Request for Class II Permissive Change

FCC ID: VG8XM142AYY Data: 2012-5-13

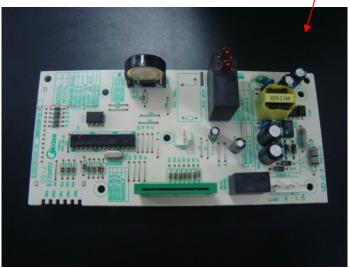
1. Updated Mainboard as below:

New mainboard &

Changed linear power supply to switching power supply

or below switching power supply.

Between of linear power supply and switching power supply have the same specification of rated output power, changed to the switching power supply, theirs rated output power have not obvious change.

The differences of between this two switching power supply only is PCB layout and components location, anything else are the same.
